**BEFORE THE INDEPENDENT HEARING PANEL
FOR THE QUEENSTOWN LAKES PROPOSED DISTRICT PLAN**

In the matter of the Urban Intensification Variation to the proposed
Queenstown Lakes District Plan

**SECTION 42A REPORT OF RACHEL GRACE MORGAN
ON BEHALF OF QUEENSTOWN LAKES DISTRICT COUNCIL**

REZONING REQUESTS FOR THE RESIDENTIAL ZONES

Figure 4: Notified UIV zoning and general location of submissions in support and opposition.

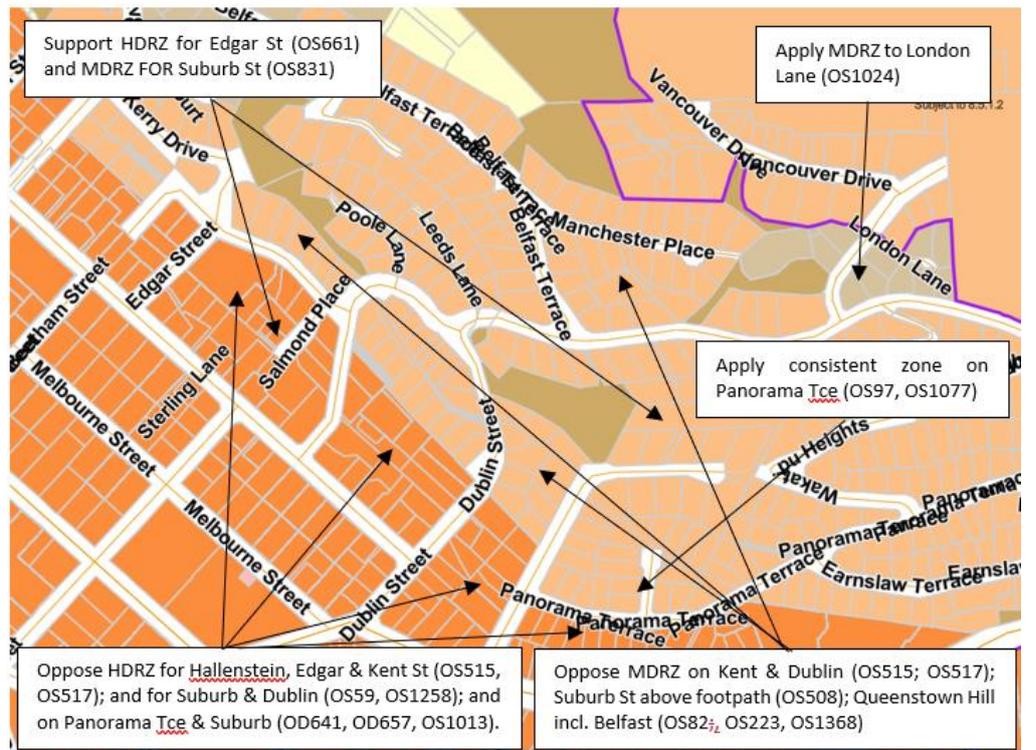
7.2 Under the notified UIV, the main change in this area is the proposed rezoning of existing LDSRZ to MDRZ, with some LDSRZ proposed to be rezoned HDRZ near the lower sections of Dublin Street and Suburb Street. 29 submissions points and 21 further submission points have been received in relation to the zoning of this area, the general location of land subject to submissions in this area is shown in Figure 4 below. The key issues raised in submissions, which seek changes to the notified UIV are summarised as follows:

- (a) Oppose the change to HDRZ for specific properties or streets including York Street, Suburb and Dublin Street and requests that it revert to the operative zoning¹⁸;

- (b) Oppose the change to MDRZ for specific properties or streets including Suburb Street, Kent Street and Belfast Street¹⁹;
- (c) Amend provisions to ensure that there should be no more than 12 residential dwellings served by the privately owned/Council maintained York Street Right of Way²⁰;

- (d) Retain the operative zoning for the block of land bounded by Hallenstein, Edgar, Kent and York Streets²¹;
- (e) Support the increased height limit and recession planes for the HDRZ within the Edgar Street locality at 7 and 5 Edgar Street in particular²²;

- (i) Rezone the “currently isolated” patch of LDSRZ land around Windsor Place /Edinburgh Drive /London Lane (12 property titles) to MDRZ²⁶.

- 7.5** I agree with the expert evidence of Ms Fairgray and Mr Wallace and do not support any downzoning or reduction in height in this area in response to submissions. In my view the proposed application of the MDRZ and the expanded HDRZ within this location would be commensurate with the area's high and moderate levels of accessibility and high relative demand for housing when considered relative to other locations in Queenstown (Policy 5) and UFD-P3 of the pORPS. My evidence above with regard to amenity values in Area 1, equally apply in this location as do my comments on Objective 3.2.2 and Policy 4.2.2.3. I further note that the land on the northern side of Hallenstein and Frankton Street is within the HDRZ under the operative District Plan and intensive multi-unit housing is already well-established

7.6 Mr Wallace has addressed submission requests in relation to the properties that seek to extend HDRZ to properties located along the northern edge of Panorama Terrace to avoid buildings of different heights on opposite sides of the road. Mr Wallace is of the view that it is preferable to utilise natural boundaries such as roads, parks, streams or steep topography as opposed to utilising property boundaries which tend to create issues around recession planes when adjoining lower intensity zones³¹. I agree with this statement, and this achieves Objective 3.2.2 and is consistent with Policy 3.2.2.1, both of which seek a logical and integrated urban form. No logical boundary exists on the northern side of Panorama Terrace.

the York Street right-of-way. The submitter requests that no more than 12 residential dwellings should be served by the York Street right-of-way. PDP Rule 29.5.13(c) already limits the number of sites served by a rear service lane to 12 residential units. It is a restricted discretionary activity to infringe this rule with the safety, efficiency, and amenity of the site and of the transport network being a key consideration. In my opinion, this rule, and any potential infringements to it, is the appropriate planning method for assessing the suitability to site access to cater for more intensive development. This would enable detailed consideration of the site constraints in the context of a specific proposal, noting that vehicle access and parking is not required and may not be provided. Regarding the suitability of the transport network in Queenstown Hill generally, I acknowledge that the area has steeper topography and this is characteristic of Queenstown's landform. As assessed by Mr Wallace, the area has a high to moderate level of accessibility depending on proximity to Frankton Road and the Queenstown Town Centre.

Figure 5: PDP zoning in Area 3 which is unchanged by the notified UIV. Also showing the general location of submissions in support and opposition.

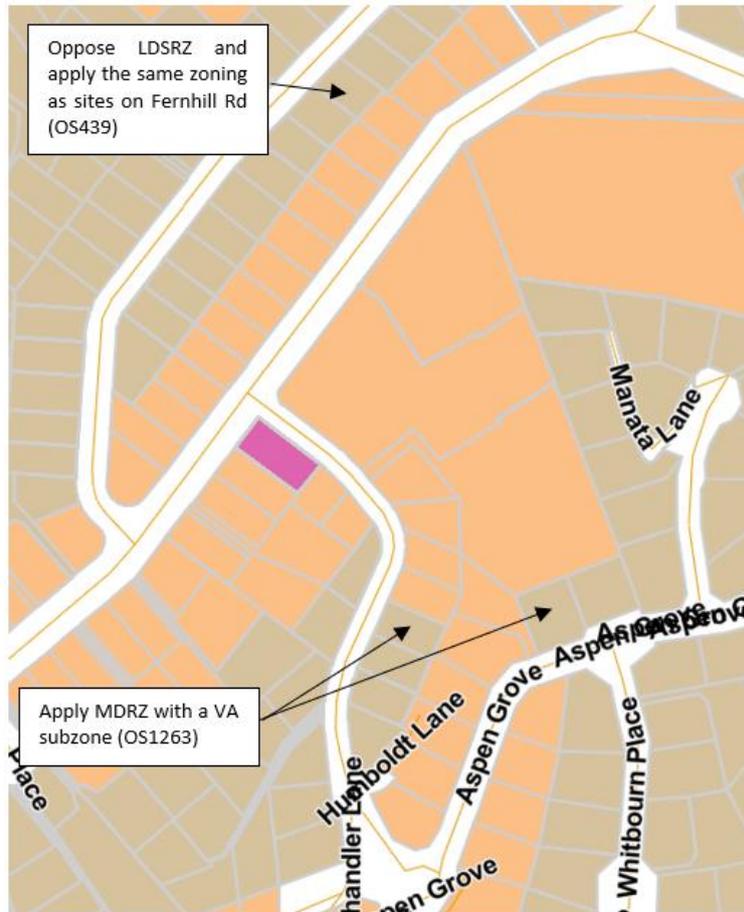
- 8.1** Area 3 includes the residential land at Fernhill. Refer Figure 5 for the PDP zoning in this area. Zoning in this area is a mix of LDSRZ and MDRZ. No change to the zoning in this area is proposed through the notified UIV.
- 8.2** Three submissions have been received in relation to zoning at Fernhill. The relief sought by the submitters is shown spatially on the plan at Figure 5. The key issues raised in submissions, which seek changes to the notified UIV are summarised as follows:
- (a) Rezone 139 Fernhill Road, 10 – 18 Richards Park Lane and 18 – 22 Aspen Grove MDRZ, and include these properties within the Visitor Accommodation Sub-Zone of the Proposed District Plan³⁴; and
 - (b) Support the mapping for Fernhill as notified and request that 45 Wynyard Crescent be rezoned MDRZ to match zoning of adjacent sites ³⁵.

8.5 I agree with Mr Wallace that the application of the MDRZ to 18 Richards Park Road will result in a logical zoning pattern and enable comprehensive redevelopment of a larger landholding, despite it having a relatively lower level of accessibility. I note that this development (two-four storeys) is currently underway and includes the site at 18 Richards Park Road.⁴¹ I also acknowledge Ms Fairgray's evidence that there is market demand that supports this change in zoning. The site at 18 Aspen Grove is not within the extent of the visitor accommodation development currently underway, although I understand that the site is owned by the developer and has resource consent to operate visitor accommodation on the site for six persons up to 365 nights of the year.⁴² I see the merit in including these sites within the MDRZ as it would enable a coherent and logical zoning boundary to extend to a road boundary and enable the area to be comprehensively developed and managed for visitor accommodation. There are currently resource consents in place that would enable this occur, although I note that this does not include the redevelopment of 18 Aspen Grove.

- 8.7** Regarding the request to include 45 Wynyard Crescent, Fernhill within the MDRZ, the existing MDRZ boundary in this location sits mid-block (between Fernhill Road and Wynyard Crescent) and responds to the significant elevation change between these roads. In Mr Wallace’s opinion the existing zone boundary is logically located and no further expansion of the MDRZ in this location is necessary. I agree with Mr Wallace that rezoning 45 Wynyard Crescent to MDRZ is not appropriate given the lack of accessibility and elevation changes between Fernhill Road and Wynyard Crescent. In my view this rezoning request will result in a “spot zone” and will not achieve a logical and integrated built form outcome.

- 8.9** Rezone 18 Richards Park Road and 18 Aspen Grove from LDSRZ to MDRZ. If the Panel consider there is scope to make this mapping change, , include these sites within the Visitor Accommodation Sub-Zone and subject to rule 8.4.11 of the District Plan.
- 8.10** For the recommended changes I make the following comments with respect to Section 32AA matters, which summarise the analysis already undertaken:
- (a) The recommended amendments to the zoning will more efficiently and effectively achieve the relevant objectives of the PDP, particularly Objective 3.2.3.2 as it will provide for built form that integrates with the adjoining and adjacent sites;
 - (b) The benefits are considered to outweigh the costs. The existing PDP zoning pattern does not align with the existing landholding which will result in an inconsistent planning framework to be applied to redevelopment of the site; and

Figure 7: Notified UIV zoning and general location of submissions in support and opposition.

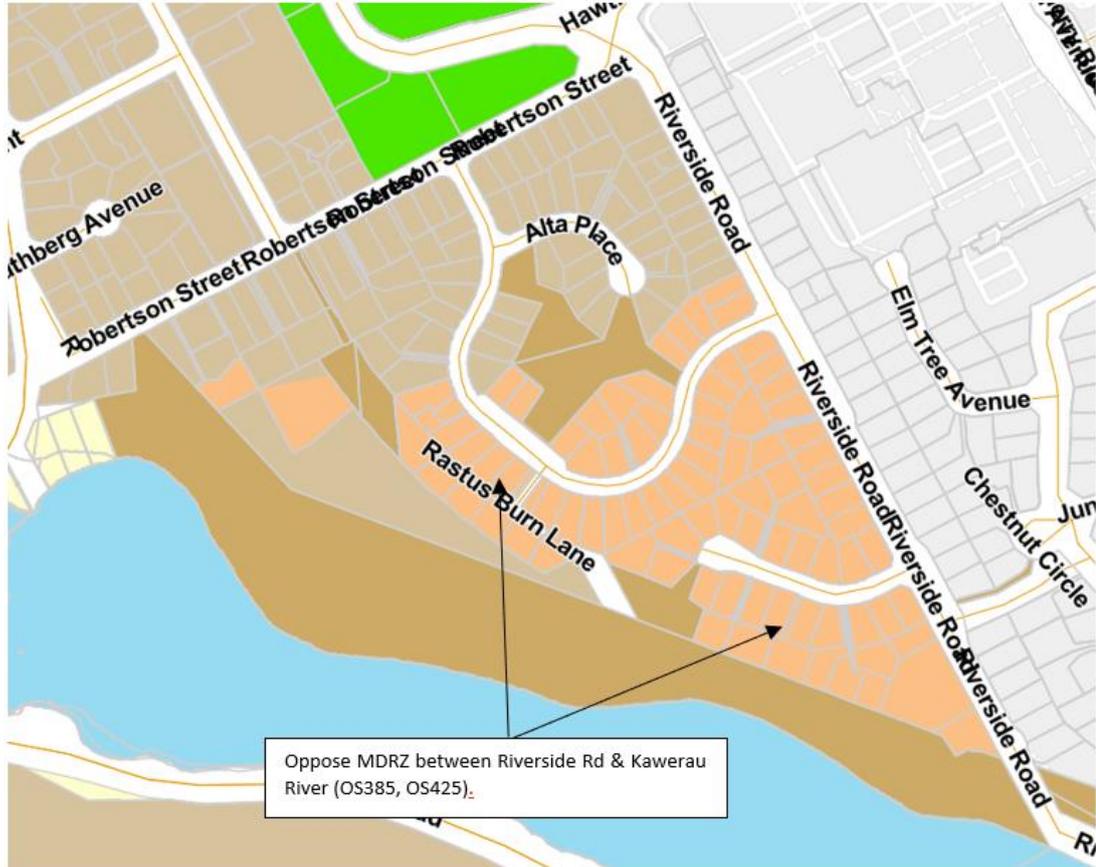
9.2 Three submissions and one further submission point have been received in relation to zoning at Remarkables Park. The relief sought by the submitters is shown spatially on the plan at Figure 7. The key issues raised in submissions, which seek changes to the notified UIV are summarised as follows:

- (c) If the development opportunity enabled by the MDRZ is taken up, this would result in a change in amenity values from the existing environment, including visual amenity, privacy and sunlight. However, consistent with the objectives and policies of the MDRZ, development is intended to provide for high quality living environments with reasonable maintenance of amenity values for adjoining residents (Objective 8.2.3) and this is achieved through the rules and requirements for resource consent; and

Figure 8: PDP zoning in Area 5 which is unchanged by the notified UIV. Also showing the general location of submissions in support and opposition.

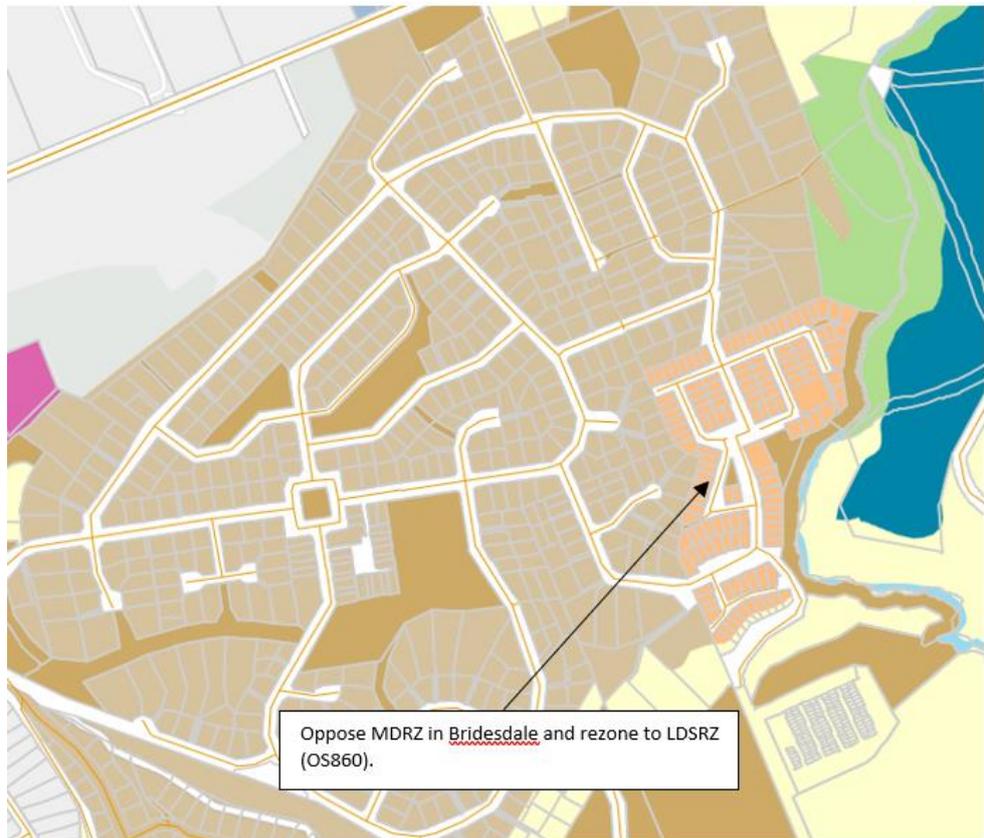
10.1 Submitter 860 seeks to change the notified MDRZ area in Bridesdale, Queenstown to LDSRZ or lower the building height to be the same height limit as the LDSRZ in these areas. Figure 8 shows the notified UIV zoning. This zoning pattern has been 'rolled over' from the PDP zoning. The MDRZ applies under the existing PDP, albeit at lower heights and densities.

- (a) The recommended amendment to the MDRZ height in this location will more efficiently and effectively achieve the relevant objectives of the PDP, particularly Objective 3.2.3.2, as it will provide for built form that better integrates with the adjoining and adjacent sites. The amendment will also support a compact, integrated and well-designed urban form (PDP 4.2.2A), noting that the area has lower levels of accessibility, and has already been largely built out, with the prospect of further development occurring in the long term being reasonably limited;

Figure 10: Notified UIV zoning and general location of submissions in support and opposition.

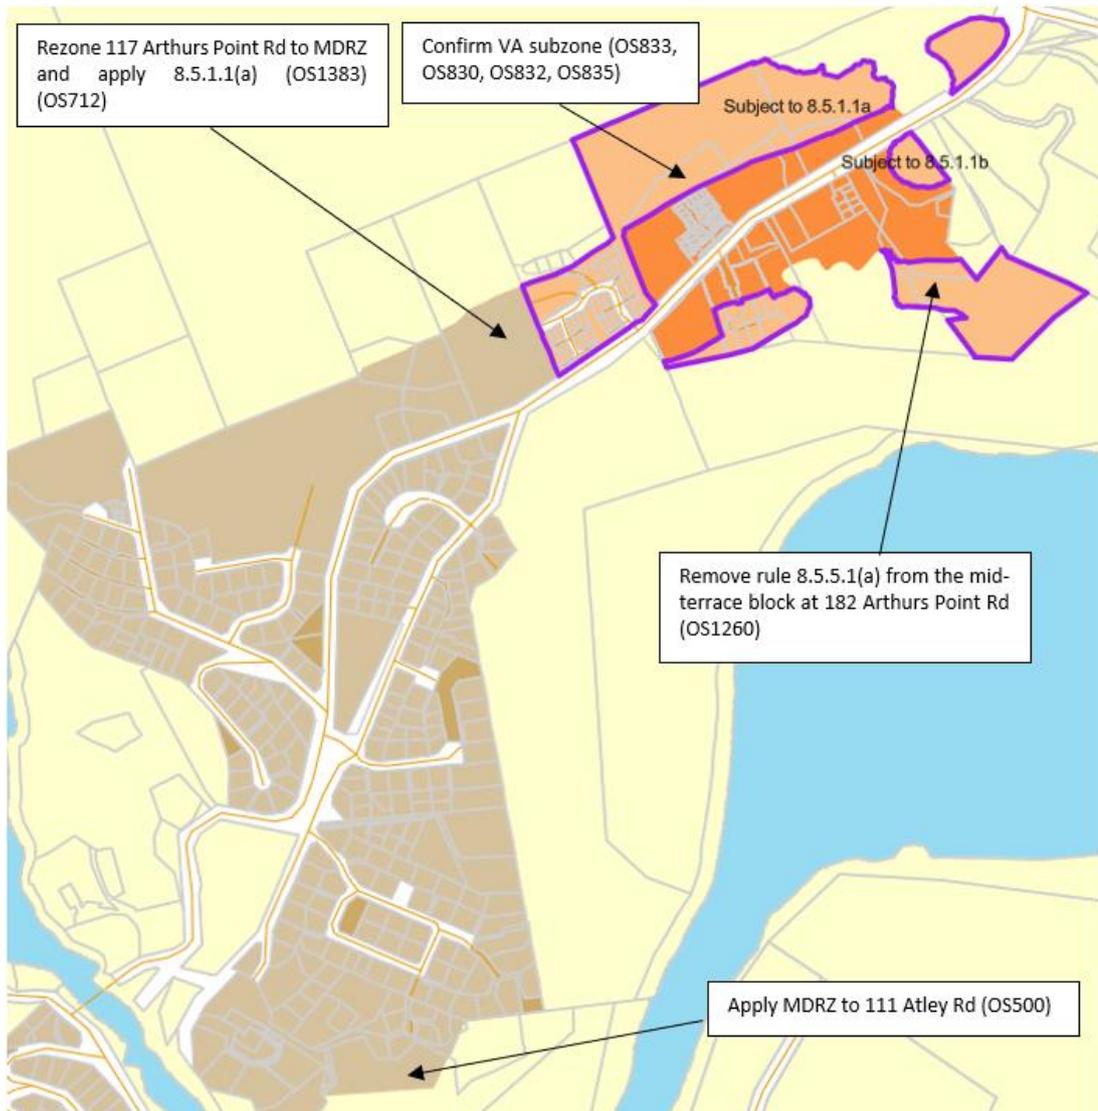
11.2 Nine submissions points and 43 further submission points have been received in relation to zoning at Arthurs Point. The notified UIV zoning and the relief sought by the submitters is shown spatially on the plan at Figure 10. The key issues raised in submissions, which seek changes to the notified UIV are summarised as follows:

- (a) Rezone the land at 117 Arthurs Point Road from LDSRZ to MDRZ and apply the location specific height notified Rule 8.5.1.1(a);⁴⁸
- (b) Rezone the land at 111 Atley Road (legally described as Lot 1-2 Deposited Plan 518803 held in Record of Title 814337) from Lower Density Residential Zone to MDRZ;⁴⁹
- (c) Retain the visitor accommodation sub-zone on the MDRZ portion of 157 Arthurs Point Road (Lot 2 DP 331294);⁵⁰ and
- (d) Remove reference to the Mid Terrace at 182 Arthurs Point Road being affected by proposed Rule 8.5.5.1 (a) and that “any reference to the site at 182 Arthurs Point Road or any other map or rule that distinguishes this site be deleted”.⁵¹

- 11.5** I comment below on the issues raised in submissions.
- 11.6** I support rezoning the site at 117 Arthurs Point Road from LDSRZ to MDRZ, subject to applying notified Rule 8.5.1.1(a) consistent with the surrounding MDRZ. The site is currently under development and has resource consent⁵² for a four storey multi-unit development on the site. Applying the MDRZ to the site would be consistent with the level of development enabled on the site, which forms part of the existing environment. The rezoning would also logically extend the MDRZ that currently applies to Arthurs Point Road to form a coherent and integrated zoning pattern.

- 11.8** In respect of the rezoning appeal, the Appellant is seeking to apply LDSRZ to the immediate south of the existing LDRSZ, and a combination of rural zones across the site, subject to a structure plan, through that process. If the existing LDSRZ part of 111 Atley Road was rezoned MDRZ (and the Appellant successfully achieves that LDSRZ relief), it would therefore form an isolated pocket of higher density zoning between LDSRZ. Even if the Appellant does not achieve that LDSRZ relief through its rezoning appeal, the MDRZ would form an isolated pocket of higher density zoning on the edge of the current Arthurs Point urban boundary.

- 11.10** The submitter's request to retain the visitor accommodation sub zone at 157 Arthurs Point Road (Lot 2 DP 331294) is noted.
- 11.11** I do not support removing notified Rule 8.5.5.1(a) from the mid-terrace at 182 Arthurs Point Road at this time. The location of the mid-terrace is shown in the submission and is reproduced in Figure 11 below.

Figure 13: Notified UIV zoning and general location of submissions in support and opposition.

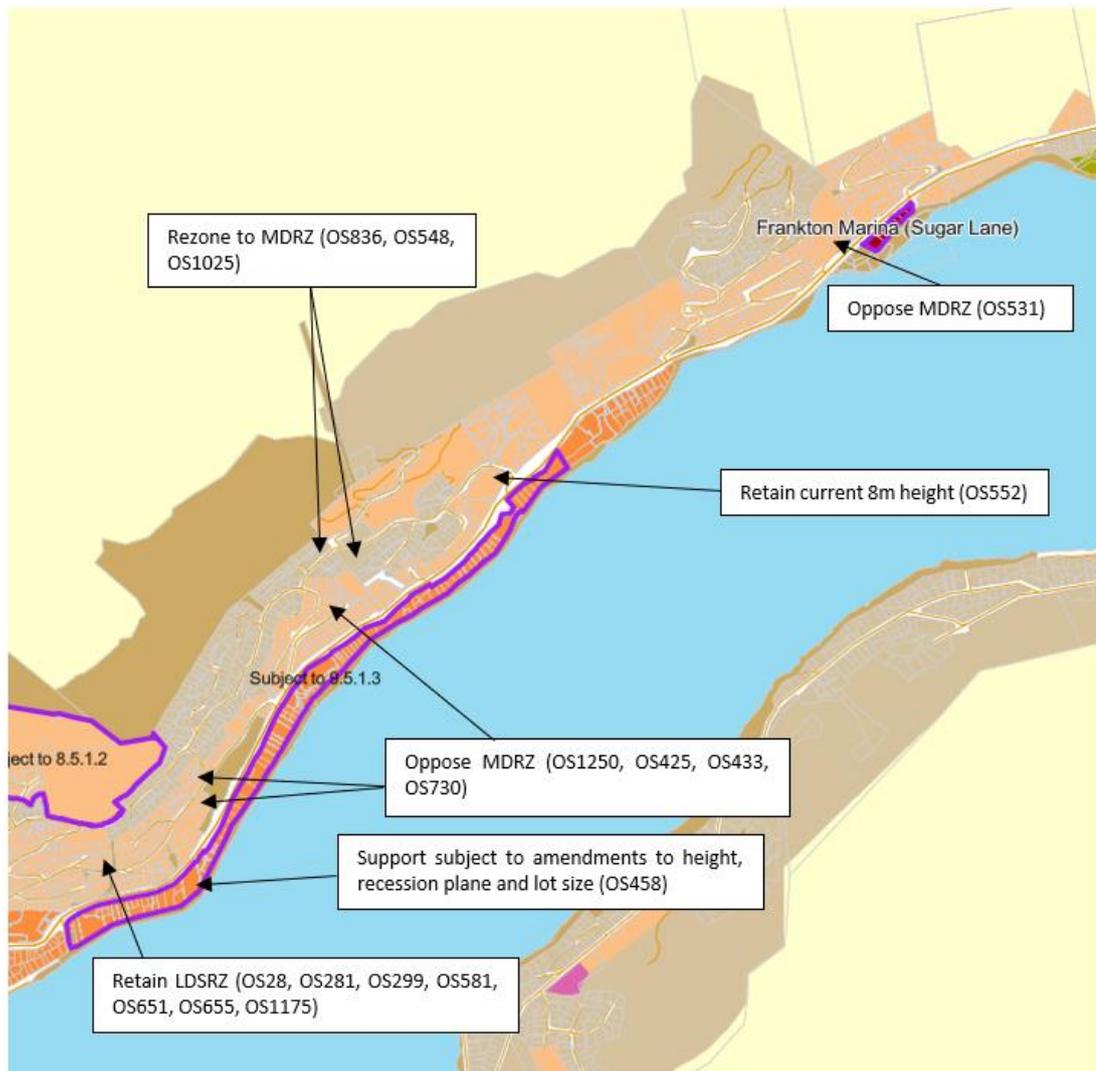
12.2 45 submissions points and 18 further submissions points have been received in relation to zoning of this area. The relief sought by the submitters is shown spatially on the plan at Figure 13. The key issues raised in submissions, which seek changes to the notified UIV are summarised as follows:

- (a) Support the HDRZ at 259 and 267 Frankton Road, subject to amendments sought related to building height, recession plane and lot size;⁵³ and
- (b) Reduce the spatial extent of the MDRZ along Frankton Road to a more feasible walking or biking distance to the Central Business District and Five Mile, such as stopping at Hensman Road, and restarting at Marina Drive toward Frankton. Alternatively reduce the spatial extent to the very lowest areas above Frankton Road.⁵⁴

- (m) Extend the MDRZ to the land accessed off Goldfield Heights Road (including along Panners Way and Golden Terrace) and up to the intersection with St Georges Avenue is rezoned as MDRZ;⁶⁵
- (n) Rezone 1 Golden Terrace as MDRZ;⁶⁶ and
- (o) Retain the 8m height limit in Goldfield Heights.⁶⁷

12.3 Area 6 includes the streets which are elevated above Frankton Road between the Queenstown Town Centre and the Frankton Local Shopping Centre Zone. I support applying the MDRZ to Area 6 as per the notified UIV as shown in Figure 12 above. I do not agree with submitters that seek to retain the operative zoning, apply a higher or lower density zone or otherwise reduce heights and densities within the notified zone rules.

12.6 In relation to concerns raised regarding the application of the MDRZ and the impact on views and sunlight within this location, Mr Wallace advises that the UIV includes several standards such as building coverage, yards, building length, recession planes which seek to provide appropriate levels of on-site amenity (including sunshine). I have addressed similar concerns as they relate to Area 1 and my comments there equally apply to Area 6. Within the context of an MDRZ, while a change in the environment would result if development occurs in line with the zone standards, in my opinion, these effects are efficiently and effectively managed by the standards and resource consent requirements for four or more residential units in the MDRZ. These effects also need to be balanced with the benefits of intensification, as expressed in Policy 6 of the NPSUD, which include the ability to support increased and varied housing densities and types.

12.8 Mr Powell outlines the three waters infrastructure capacity in Frankton. He states that various upgrades are planned via the LTP, including the Quail Rise Reservoir, which will provide additional water storage to service Frankton. Upgrades to the Frankton wastewater network are also planned which would provide additional capacity to cater for growth. Stormwater would be managed via the Code of Practice and would be addressed on a case-by-case basis. While some adjustments to the timing of infrastructure projects may be needed in the future in response to demand, Mr Powell confirms that there are no fundamental three waters infrastructure issues in catering for the level of growth envisaged by the UIV in Frankton.
